# Groundwater Transfer Review Summary Form

Transfer/PA # T- 13805

Application: T-13805

Applicant Name: Bryan Schurter/Harry Klopfenstein

**Hydrograph showing available water level data for the three wells involved in the proposed changes, in addition to nearby MARI 6079. All wells target the CRBG aquifer, display similar water level trends and elevations, and have tripped decline triggers on their respective rights.**

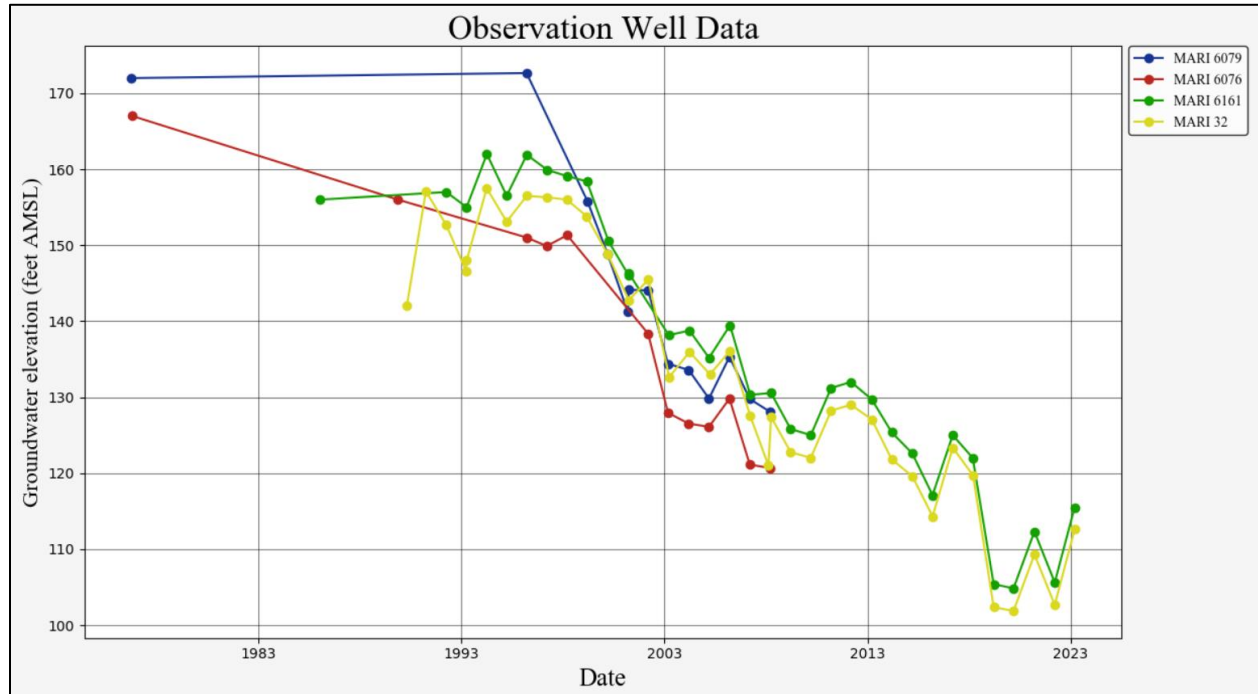
2. Will the proposed POA develop the same aquifer (source) as the existing authorized POA?  
☒ Yes ☐ No Comments: The authorized well and the two proposed APOA wells produce from CRBG. In addition, water level trends in the three wells are very similar, displaying roughly 50 feet of decline over a period of 30 years.

Existing Authorized POA for <a href="#">Cert 95208</a>	Reference Level Depth Below Land Surface (feet)	Max Decline Below Reference Level (feet)	March 2025 water level at MARI 6161 ( <a href="#">hydrograph</a> )	Permit decline condition exceeded?
MARI 6161	94.0	25	142.72	Yes

8. What conditions or other changes in the application are necessary to address any potential issues identified above: \_\_\_\_\_
9. Any additional comments: The high diffusivity of the CRBG aquifer shared by these wells is anticipated to result in similar year-upon-year declines exhibited throughout the previous 30 years of water level records if this transfer is approved.
